SCI 823 – High Fill Culvert Analysis

**Re: Bearing Capacity and Settlement Evaluation
(Culvert at STA. 404+13)
SCI-823-0.00 Portsmouth Bypass
DLZ Job No.: 0121-3070.03
Document # 0020**

PREPARED FOR: ODOT, District 9
PREPARED BY: Ram Nunna/Transystems
SUBJECT: Response to ODOT-9 comments on the Design of Four High
Fill Box Culverts dated June 22, 2007
DATE: July 19, 2007

This memo also documents the response to the ODOT review comments dated June 22, 2007.

APPENDIX D
LOCATION 1
STA. 234+00 & 239+00

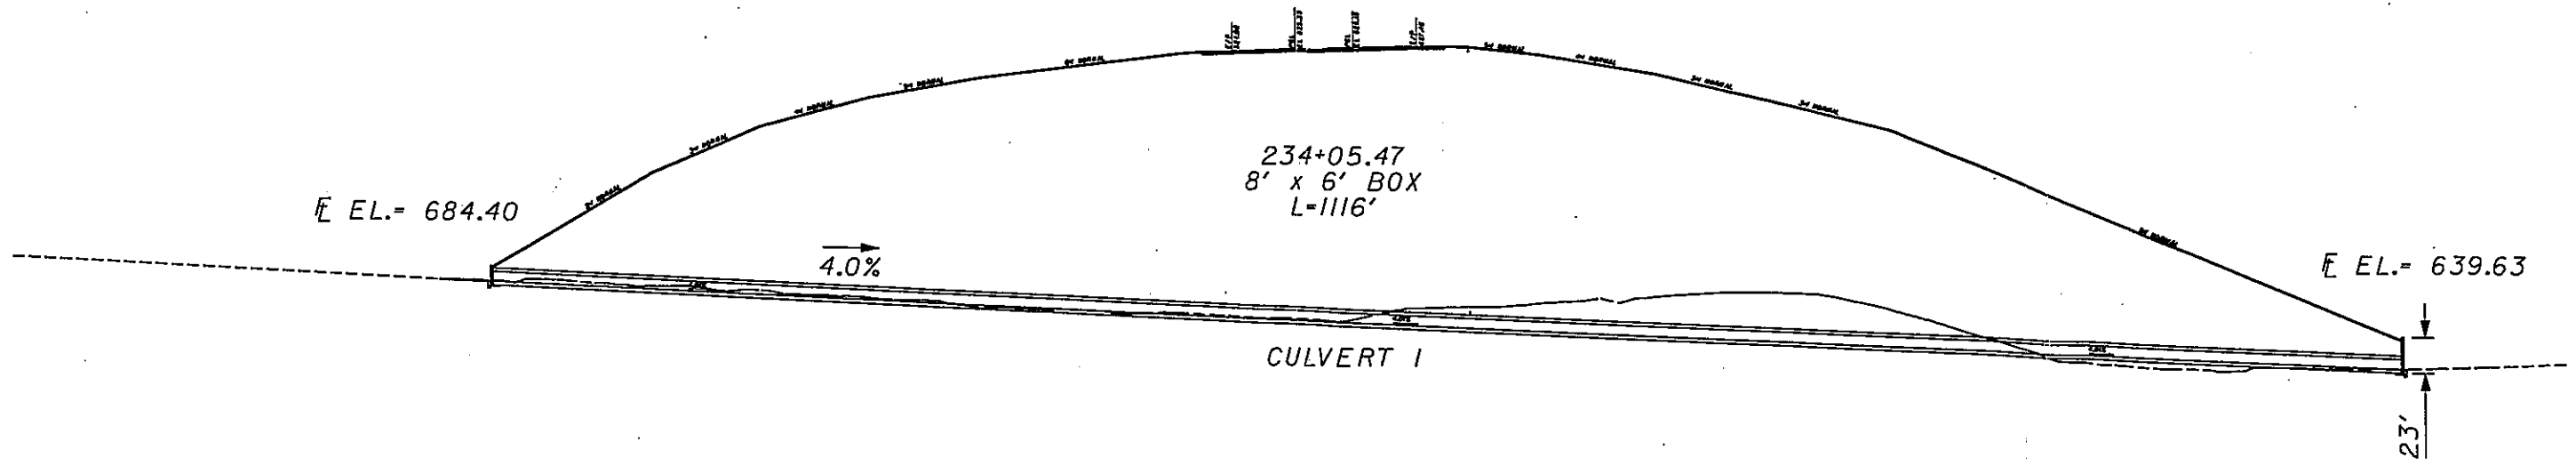
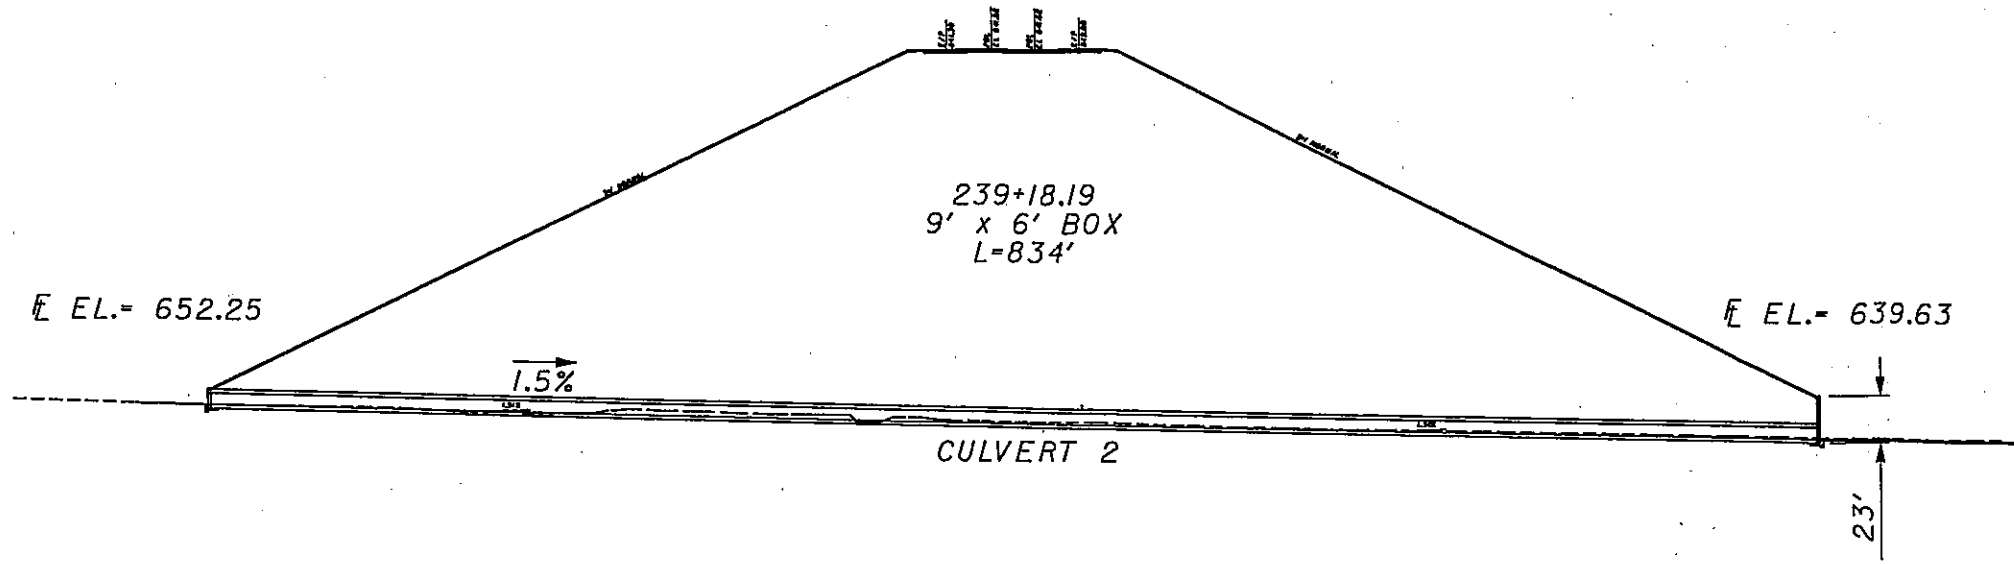
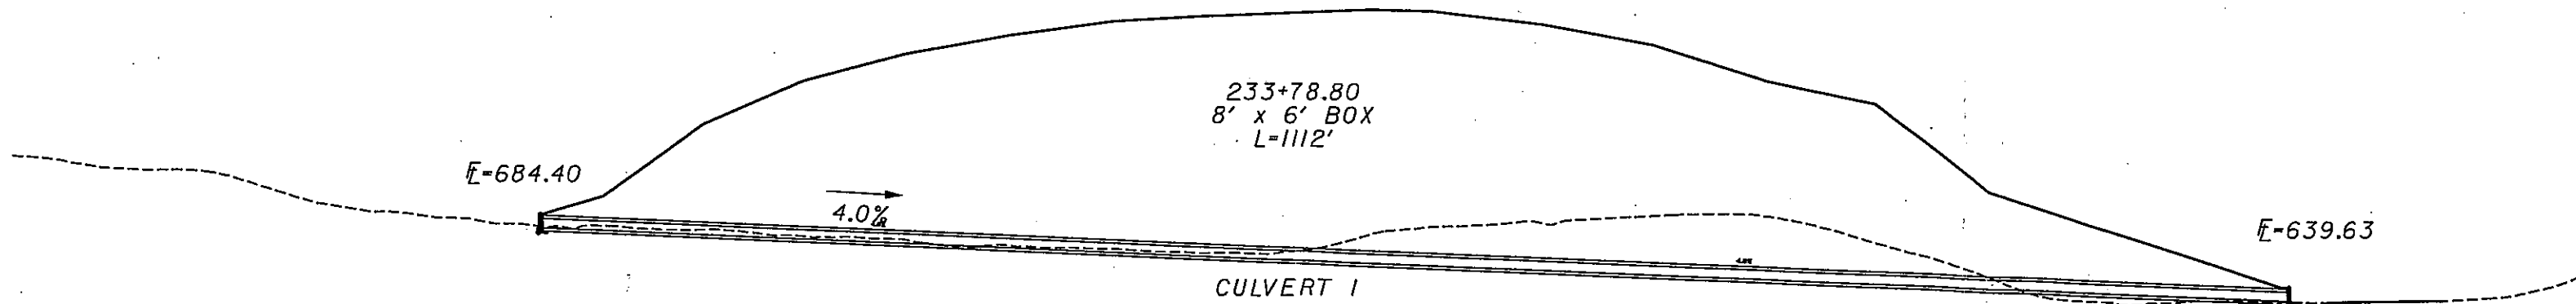
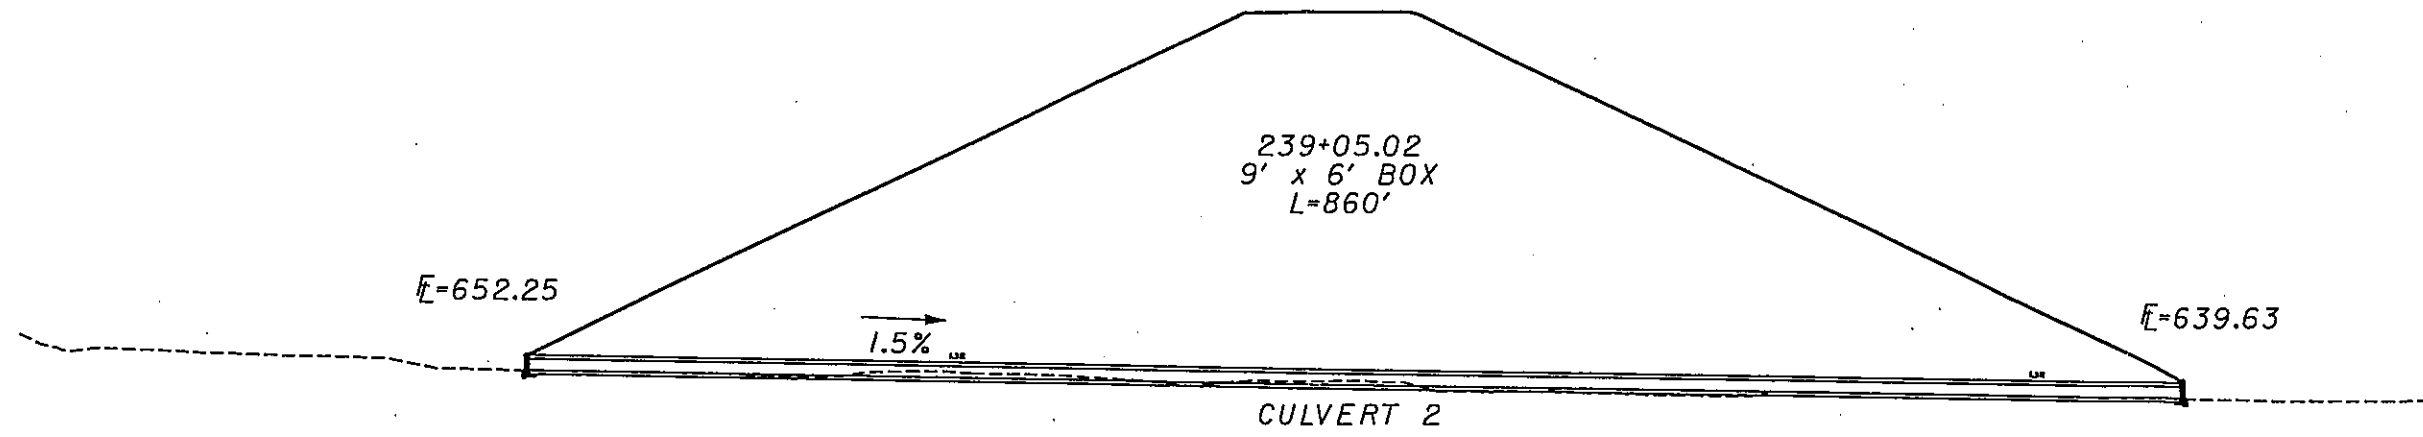
Comment # 1: It appears that the 9'x6' culvert located at Sta. 239+18.19 could be extended thereby reducing the need for the 25' AS Per Plan headwall. Would not the culvert be at or close to the toe of the embankment if you were to extend it 50'. Would there be a substantial cost savings incurred by being able to use a standard headwall? By lengthening the Sta. 239+18.19 culvert this would force the Sta. 234+05.47 culvert to be relocated (rotated approximately 1.25 degrees clockwise) and it appears more excavation would be required by this relocation. However, would the cost savings from the standard headwall vs. 25' As Per Plan headwall cover the addition excavation and culvert construction?

Response: Two Options were evaluated (See Appendix D for plan view and profiles view) at this Culvert Location and Option 1 was presented in the memo Dated May 3, 2007.

Option 1: As per Plan Headwalls

APPENDIX D
LOCATION 2
STA. 297+50 & 300+80

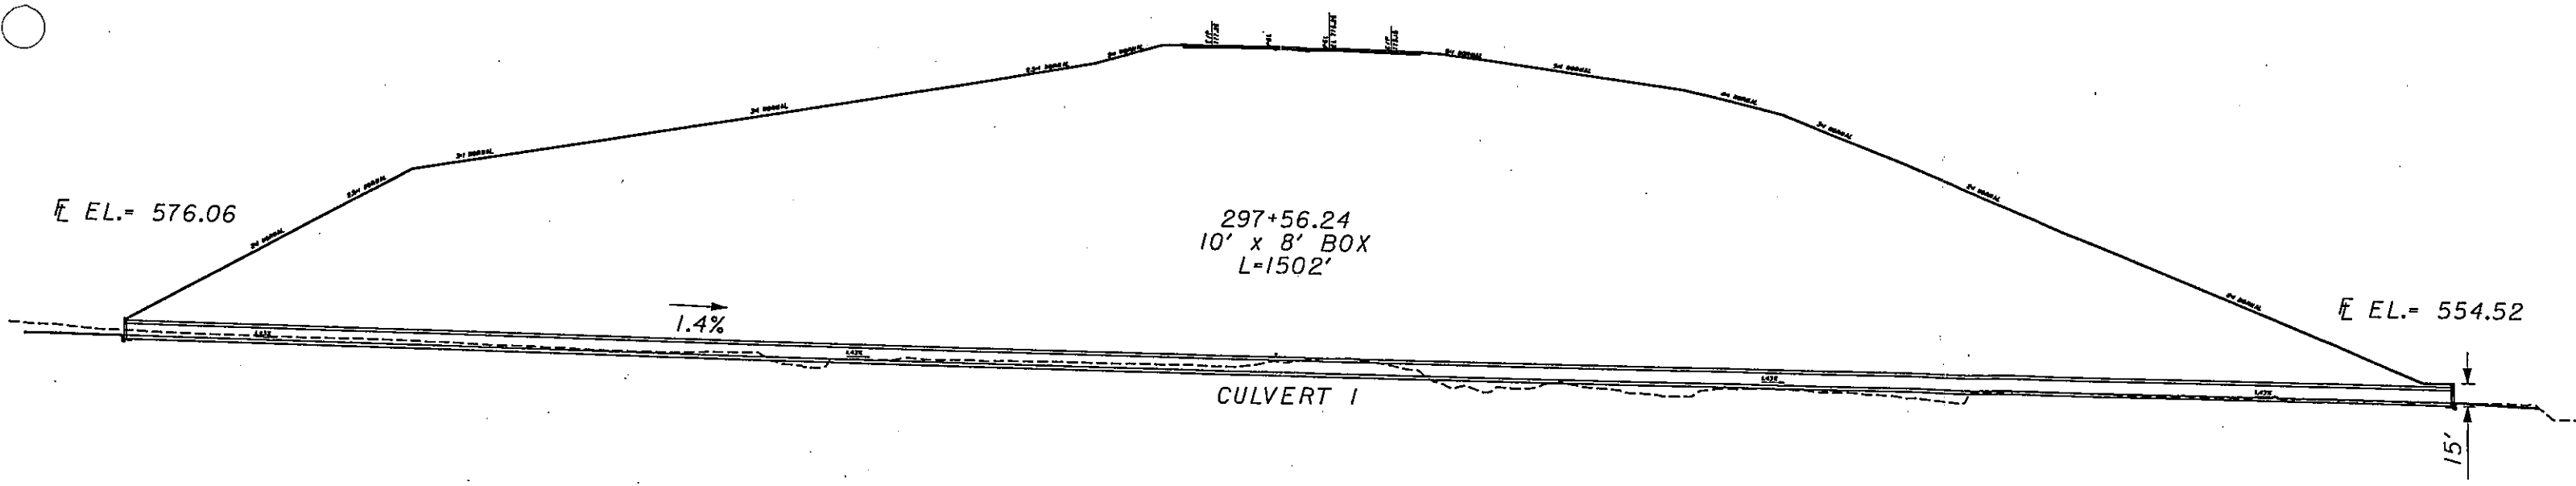
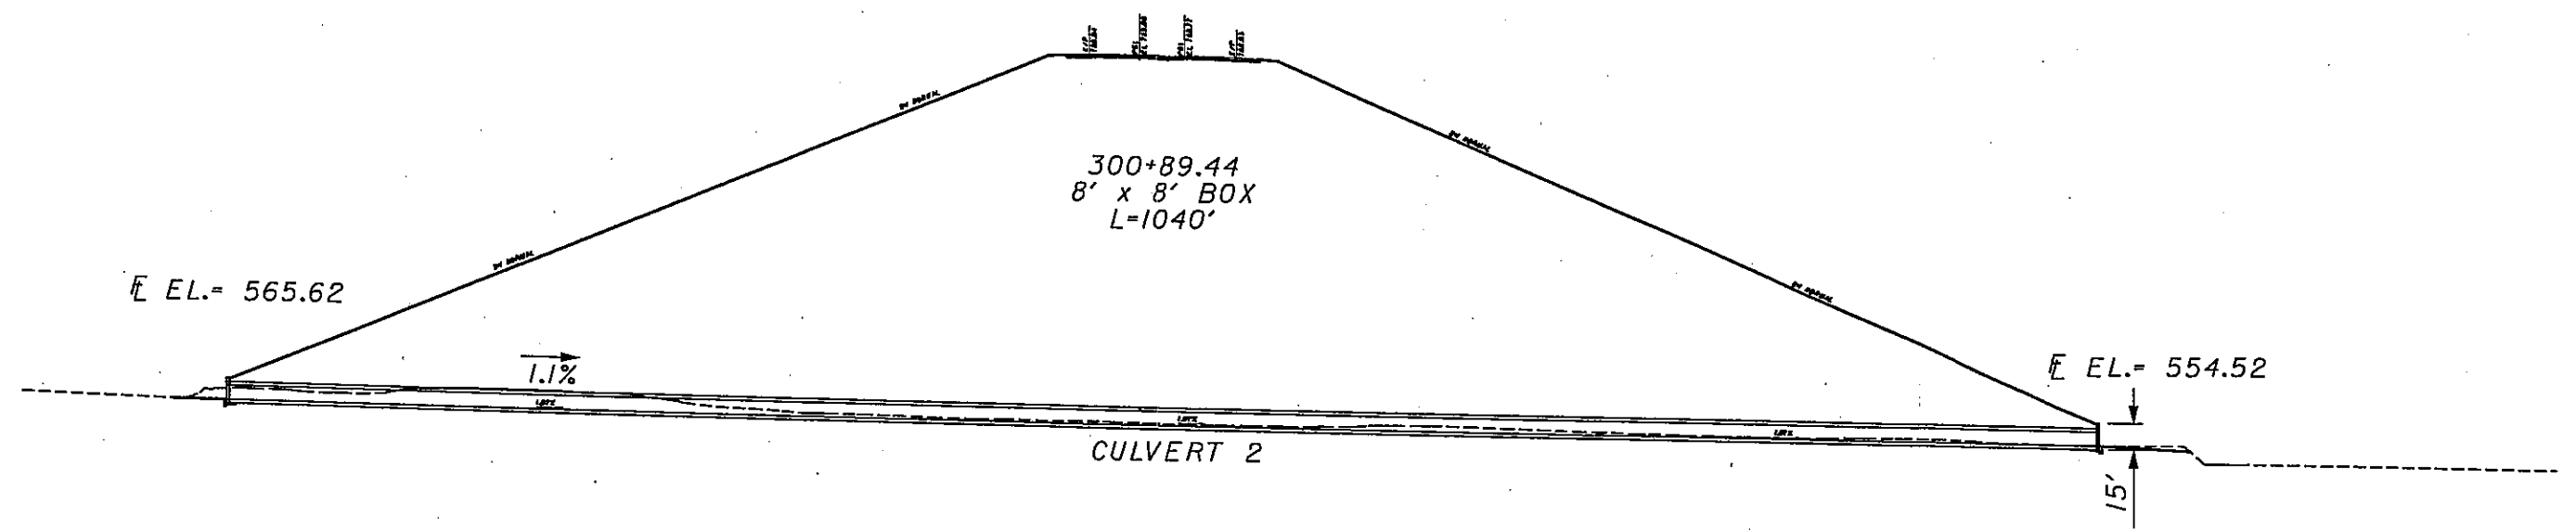
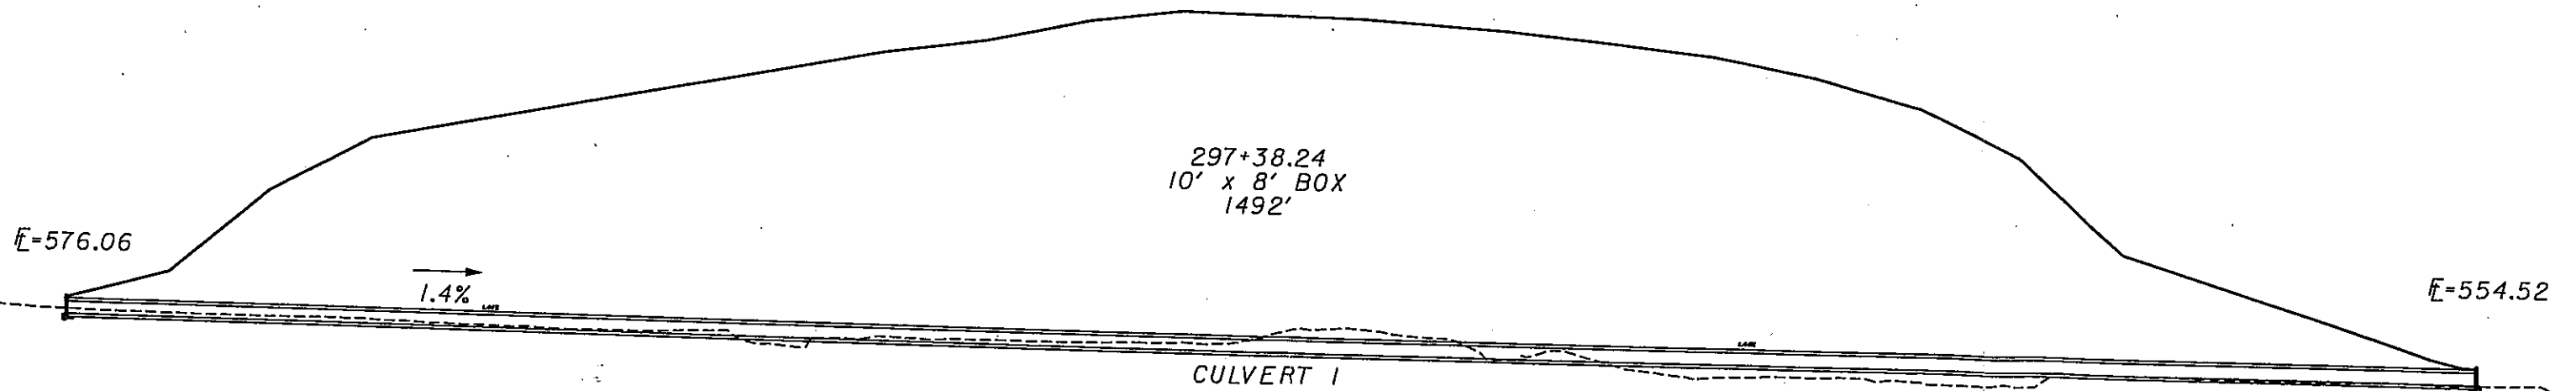
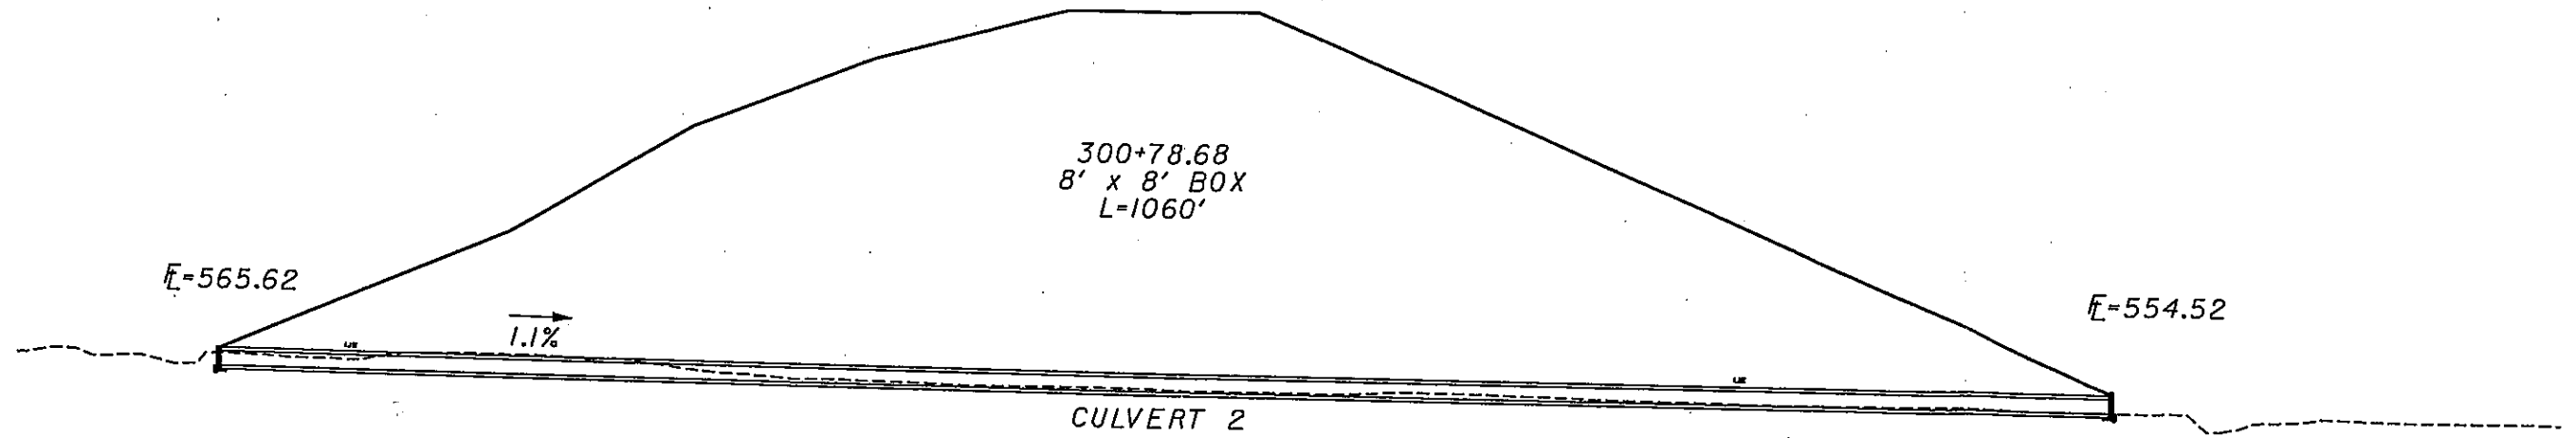
Comment# 1: Can the 8'x8' culvert at Sta. 300+89.44 be extended also. This would be described similar to that as stated in Item No. 1 in the previous comments (Culvert at Sta. 234+05.47 & Culvert at Sta. 239+18.19).

Comment#2: Could the culvert at Sta. 300+89.44 be relocated approximately to Sta. 301+65 with the inlet at the intersection of the roadway ditches and the existing stream? This alignment would follow the approximate toe of the existing slope and more earthwork maybe involved. However, it would also provide a better transition from the outlet to the existing stream.

Response: Two Options were evaluated (See Appendix D for plan view and profiles view) at this Culvert Location and Option 1 was presented in the memo Dated May 3, 2007.

Option 1: As Per Plan Headwalls

In the memo dated May 3, 2007 the As Per Plan Headwall height was shown as 17' which is incorrect. Actual height is 15'

Response: The Culvert can be relocated. It produces 5,500 cu.yds of extra rock cut.
